ARDROSSAN HARBOUR REDEVELOPMENT PROJECT MARINE WORKS LONG LIST OPTIONS

04/02/19

ARDROSSAN HARBOUR DEVELOPMENT PREFERRED BERTH OPTION REVIEW

BERTH WORKSHOP 12TH FEBRUARY 2019

Option 1 (Original Base Case)

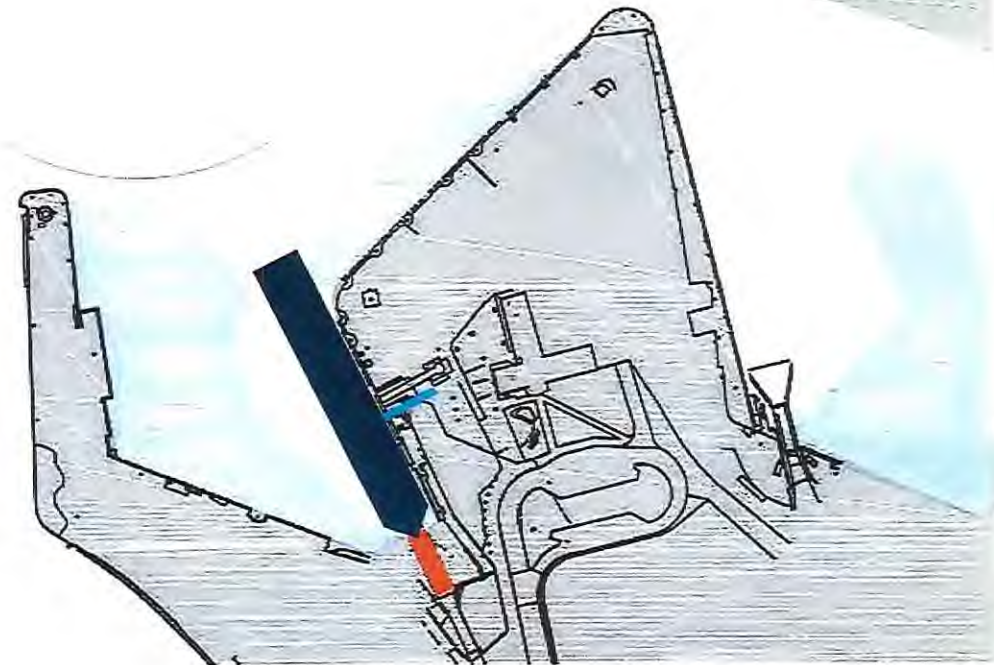
- Not supported by Calmac as MV Glen Sannox cannot easily navigate on to the berth and provides very low resilience.
- Also the vessel overhangs the berth.
- Discussion around adding canting dolphin / roundhead (as seen at eg Rosyth ferry terminal) to assist berthing manoeuvres but Calmac felt (and PPG Harbour master/pilot agreed) this only reduces the available space.
- Discussion around adopting moormaster or similar automatic mooring to deal with the vessel overhang but ultimately the navigational issues rule this option out anyway.

Not Taken Forward

Option 1A (Initial Ramboll Design)	
Primary Berth	Arran
Secondary Berth	Irish
Arran Berth Works	
• Replacement linkspan	
• Recess for linkspan	
Irish Berth Works	
• Refurbishment of suspended deck	
• Refurbishment of linkspan

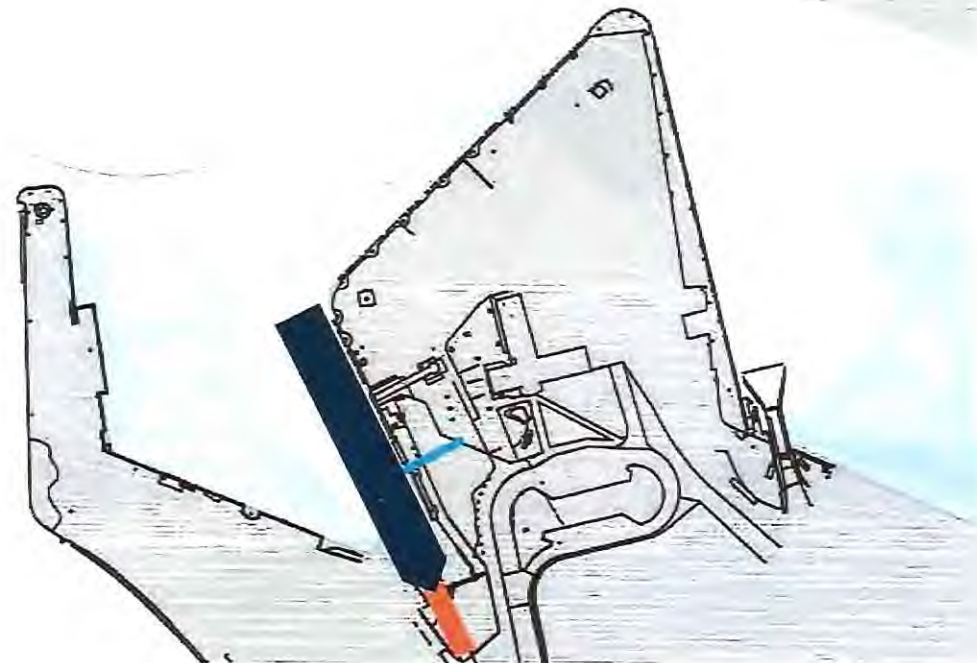
This option is similar to Option 1 but deals with the issue of the reduced quay length for mooring by recessing the linkspan. However it does not deal with the fundamental navigational issues.

Not Taken Forward

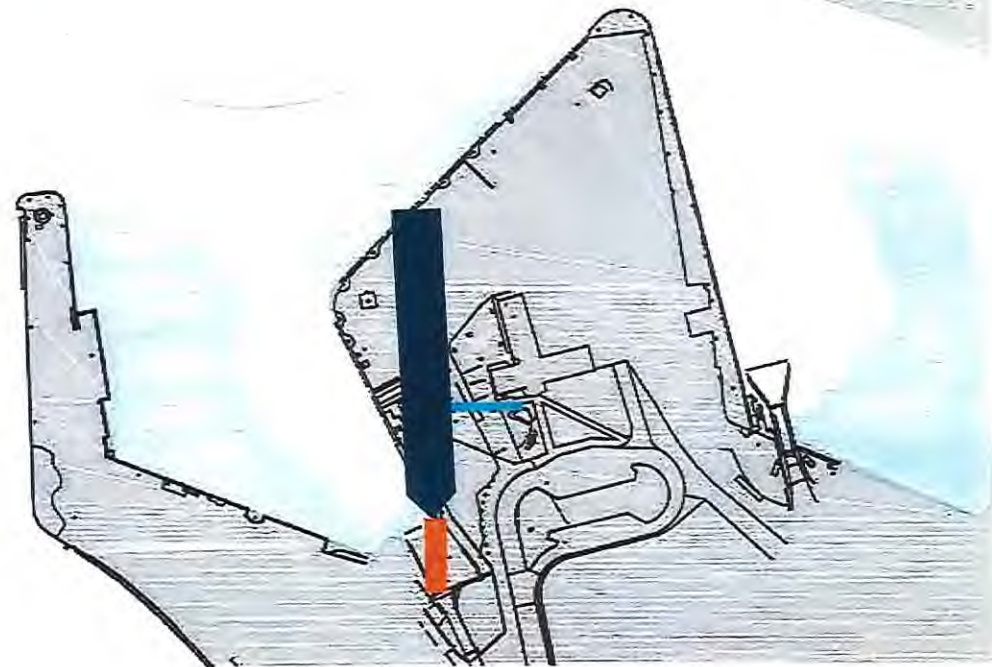
- This is the current option 2 scheme under discussion. This is preferred by Calmac as they feel it addresses the navigational issues and provides better resilience on the Arran berth (see other notes for comments on two berth operation)
- Recognition from the meeting that this is not without its challenges:-
 - PPG/NAC/Arran community rate the retention of the service very highly in assessment and this option will make it very difficult to do so as the Arran berth is not available for the majority of the time meaning a service to Irish berth only (refer to Calmac papers on this topic)
 - The recent SI work has identified a number of structures within the area to be demolished / excavated giving rise to potential technical challenges, cost, programme and risk issues.

Taken Forward

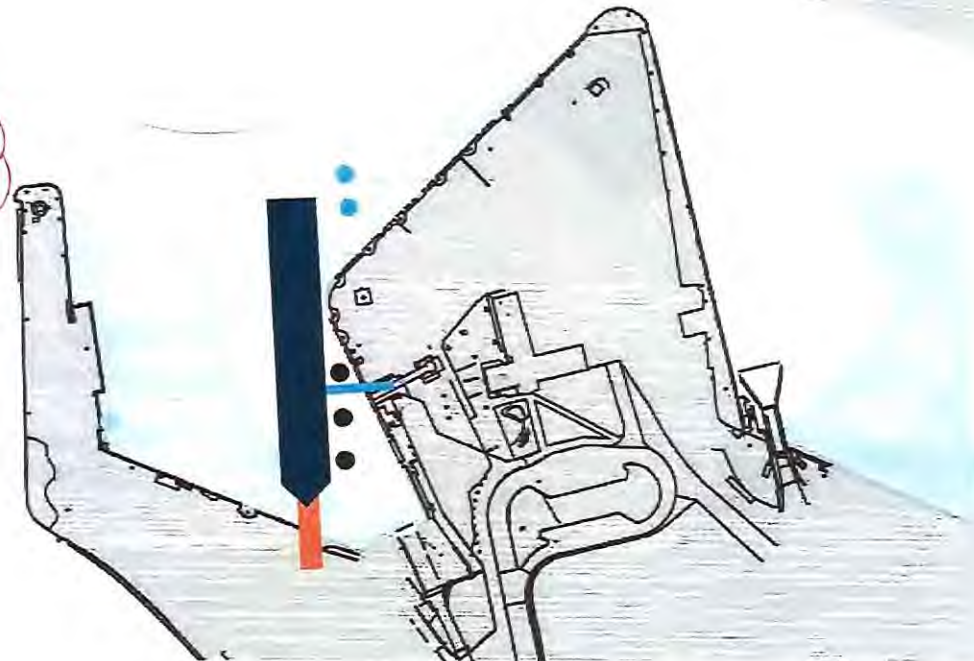
- Provides the programme benefit that the linkspan could be constructed off line and potentially shorter construction period as less disruptive.
- Provides some benefits landside as it removes the requirement for pedestrian crossing from car park across the marshalling area.
- Dolphins make the navigation more difficult (less available space and requires a greater turn)
- Some concerns over wave climate and reflected wave / swell at the bow would require some work.
- Challenging manoeuvre when leaving the berth.
- Reduces resilience due to vessel movements.

Not Taken Forward

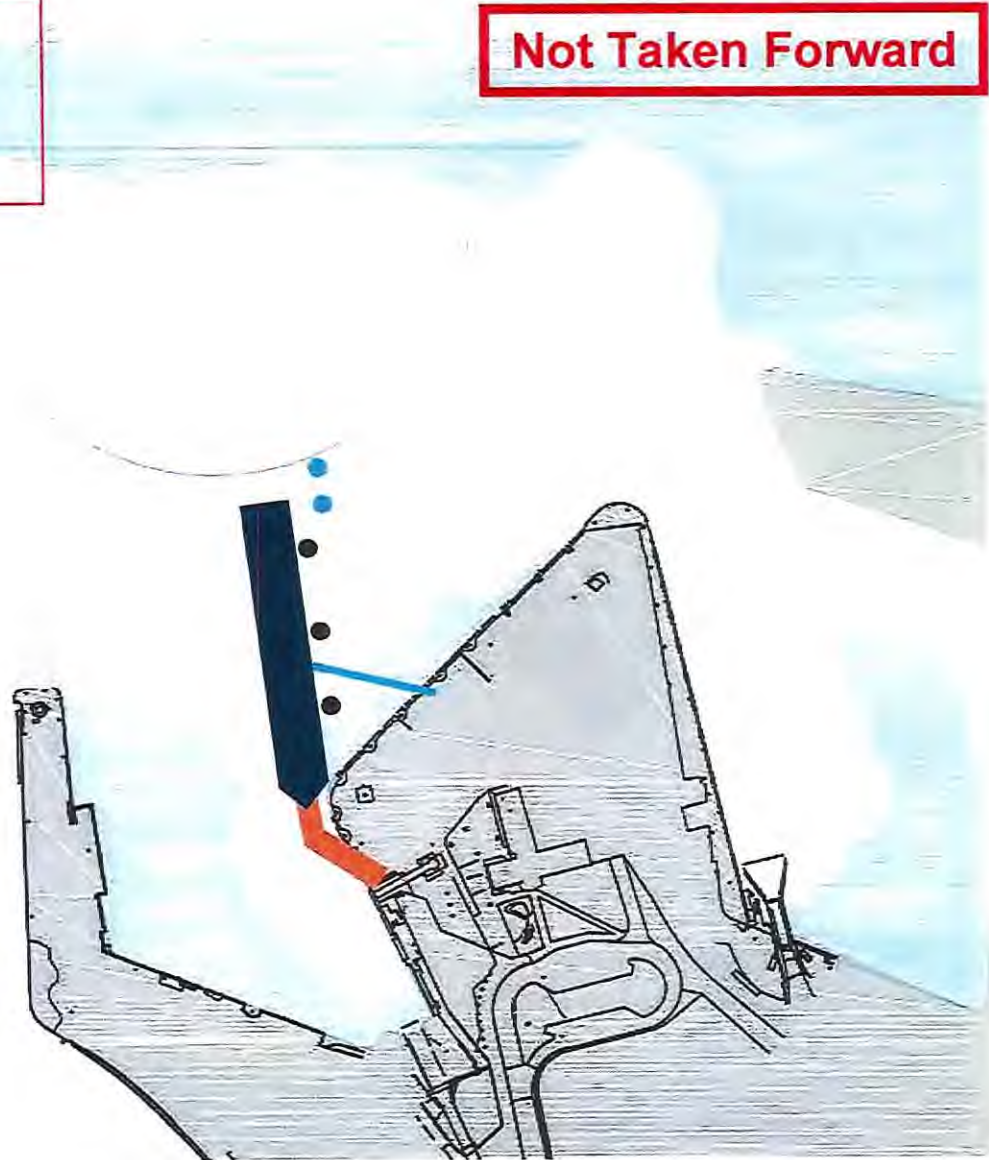
One of the more "out there" ideas and no one could see any benefits but worth reviewing just to rule it out if nothing else.

- Less space to manoeuvre, more exposed berth
- more complicated landside set up.

Not Taken Forward

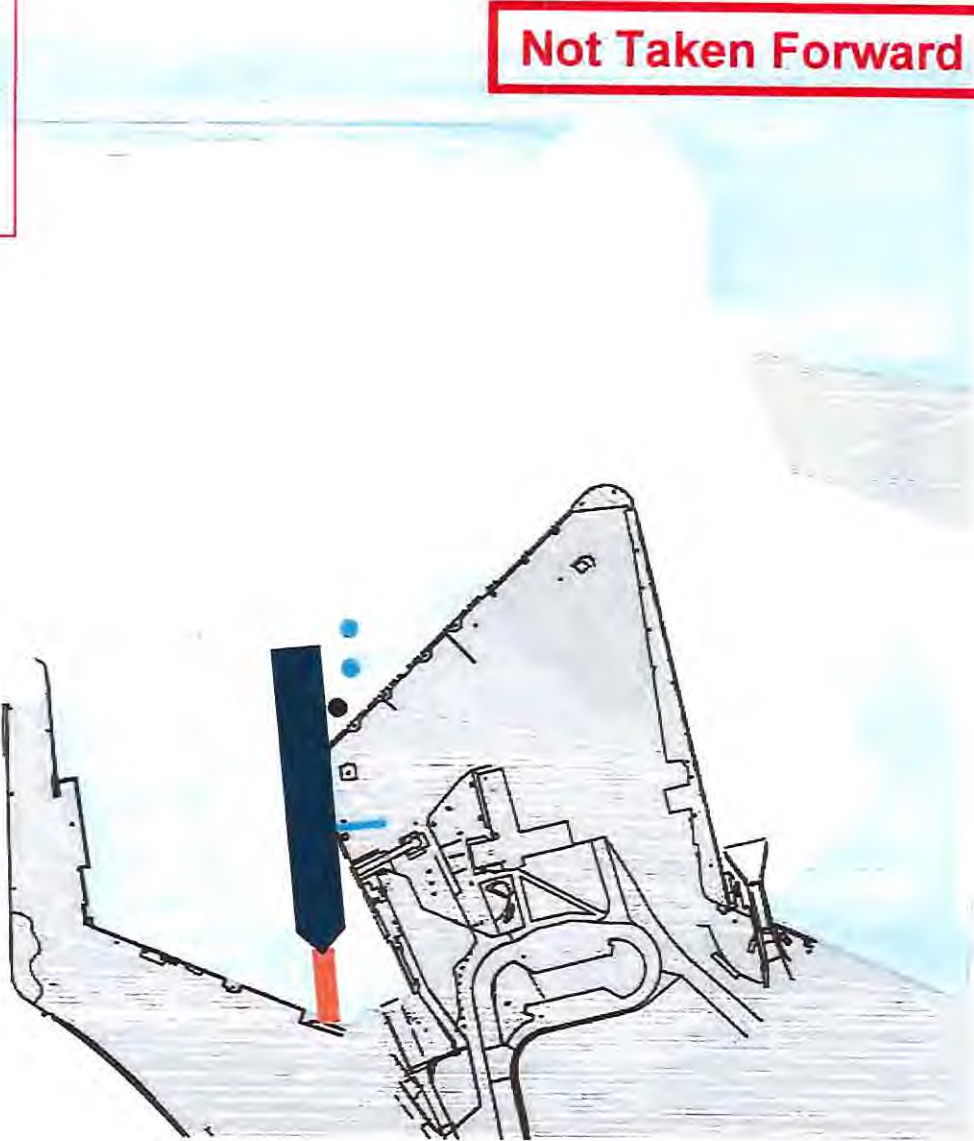
Moves the vessel across slightly from option 3 to provide more space.

- Dolphins present a potential impediment / reduce space
- exposure to waves around the breakwater and/or breakwater enhancement required.

Generally not considered viable.

Not Taken Forward

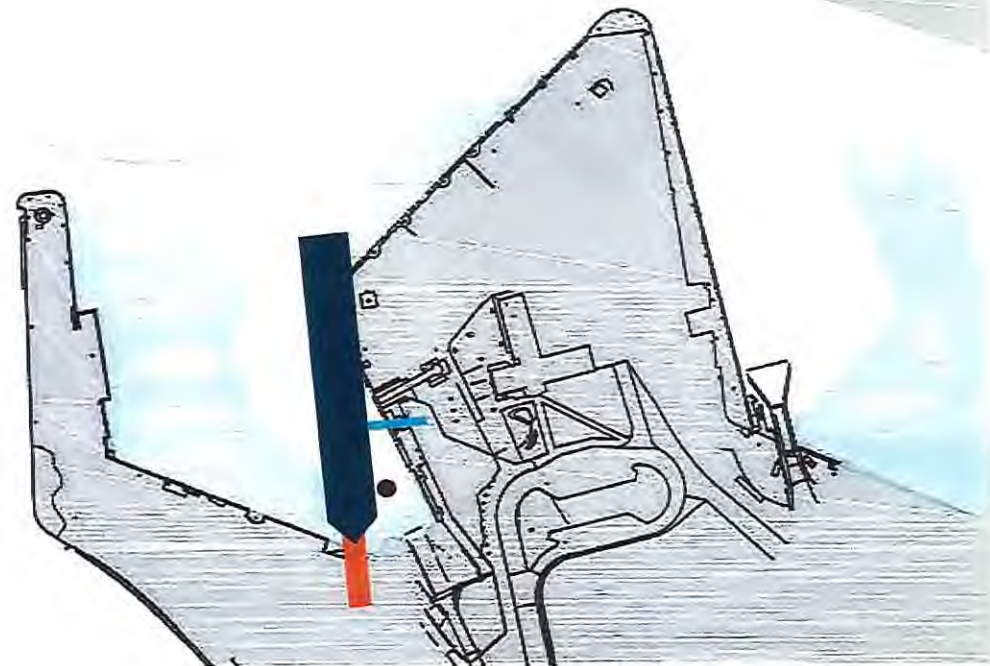
GMcG Meeting Notes
See option 7 for comments

Taken Forward

Option 7

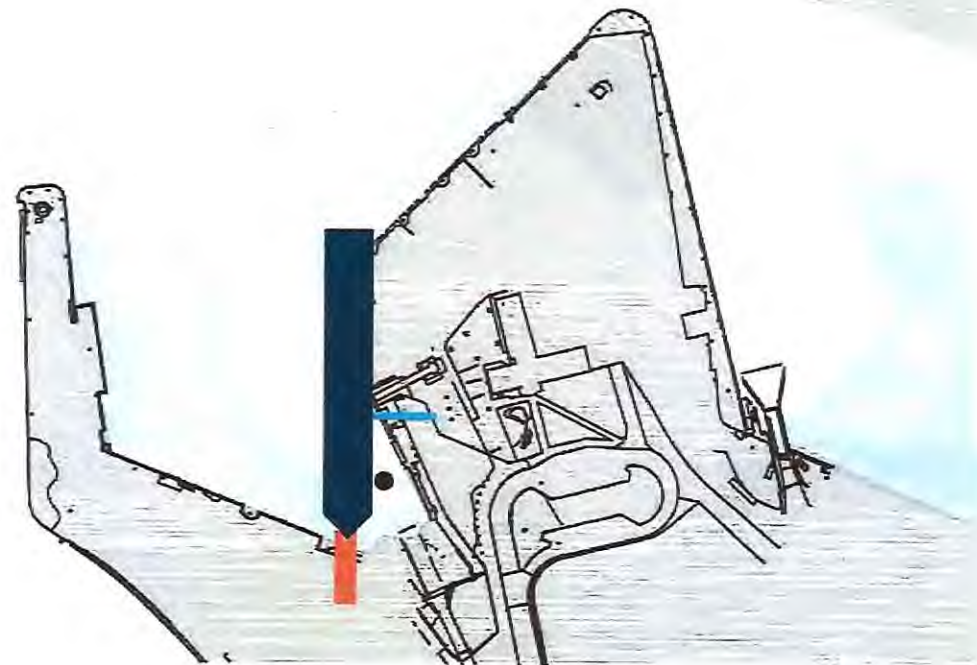
Option 6 and 7 were discussed together and it was agreed that something between or around this might be worth developing further. Ramboll agreed that these are only indicative and that geometry / exact positioning needs working on.

- Similar alignment to Option 2
- Benefit over 2 of less demolition and less construction (better for programme, cost, risk and disruption)
- Work to be done on potential swell conditions around the bow. Possibly a solid wall rather than dolphins but still shorter than Option 2.
- Calmac comments 7 is better than 6 and 2 is better than 7 but it is worth exploring further particularly on the balance of cost / programme.
- There are masterplanning / landside benefits as, due to the linkspan position, you can flip the current car park and marshalling yard positions and remove the requirement for crossing point.

Taken Forward

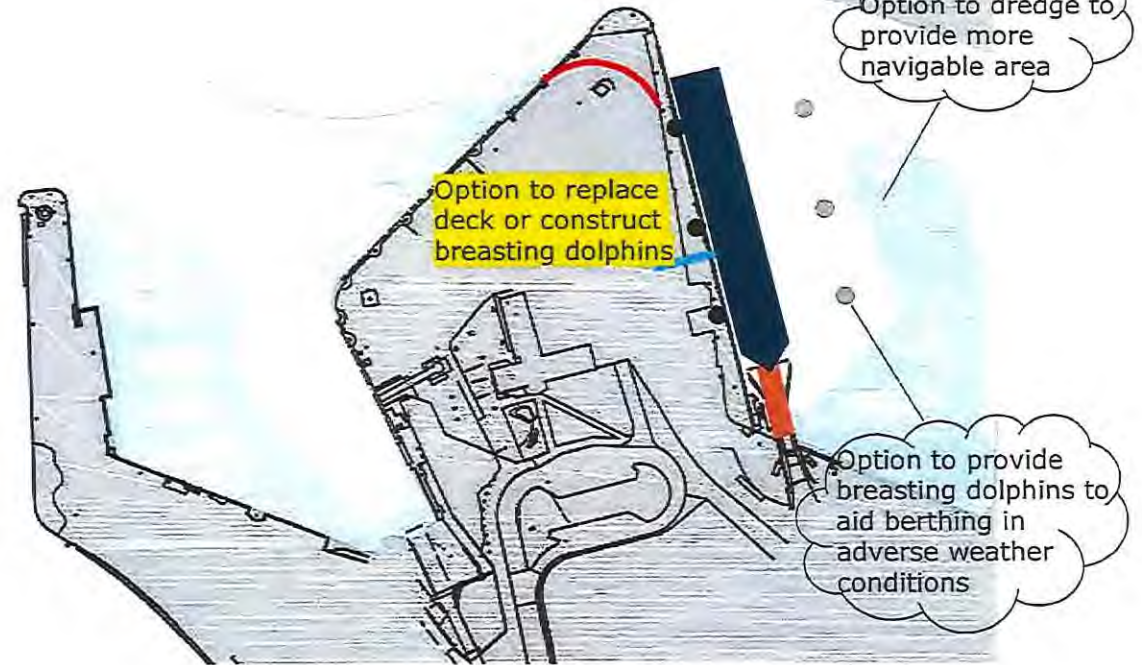
Strengthens the Irish berth by removing the suspended deck sections and replacing with mooring dolphins.

-Clear operational advantage during the works as Arran berth is left in use for the duration.

-Albeit not insurmountable it creates landside complications of ped / vehicle flows that are not ideal.

- Navigation challenging in the most prevalent SW wind conditions so likely reduces resilience.

-Provides next to no contingency for berthing

-These comments on navigation and landside apply to pretty much all of the Irish Berth only options. Non were taken forward.

Not Taken Forward

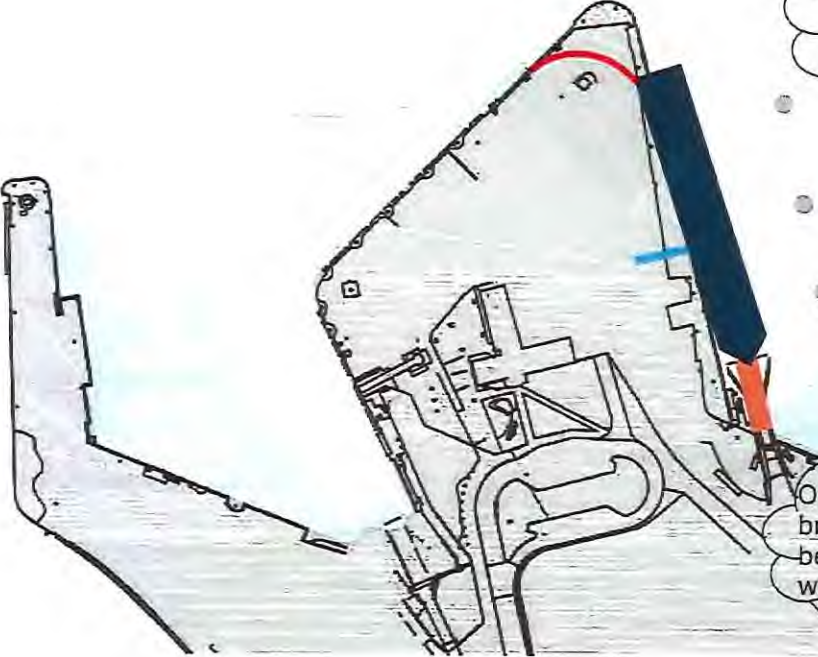
GMcG Meeting Notes
See 8 for comments

Not Taken Forward

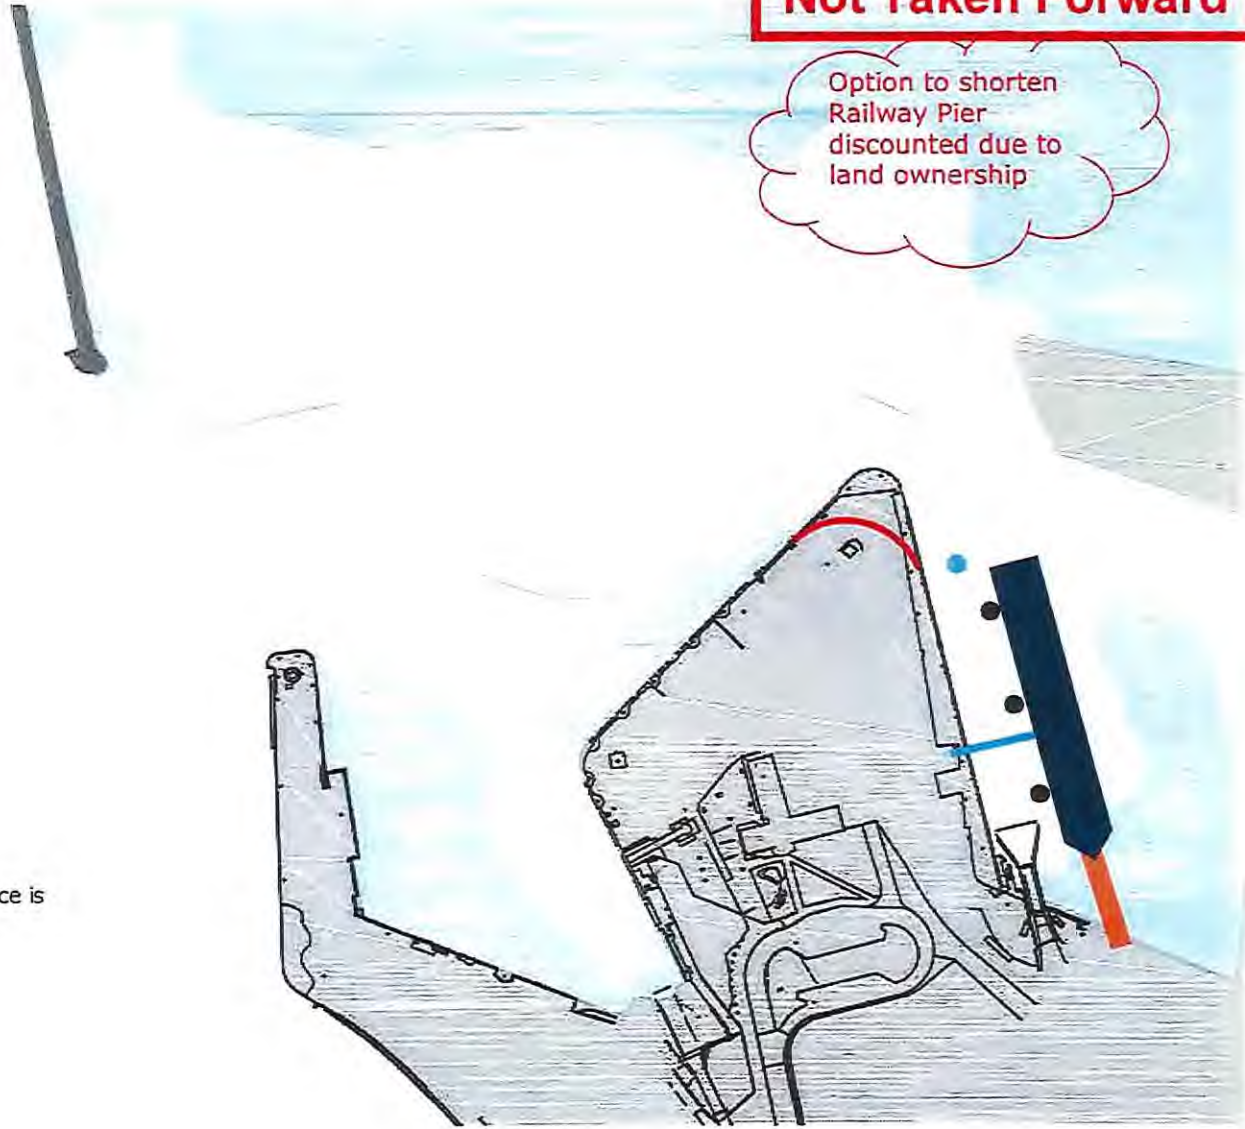
GMcG Meeting Notes
See 8 for comments

Not Taken Forward

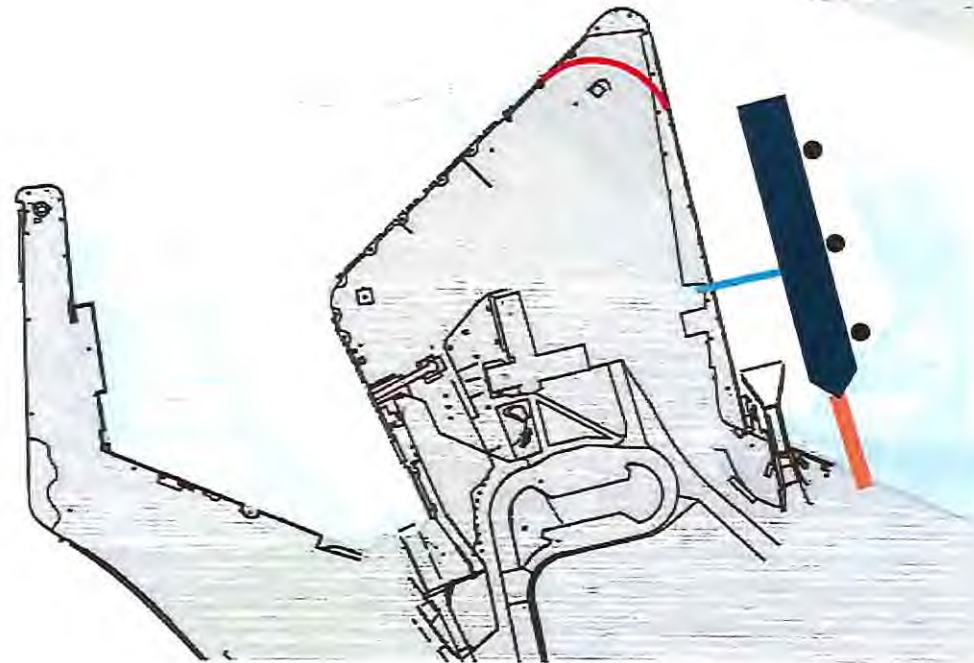
GMcG Meeting Notes
See 8 for comments

Not Taken Forward
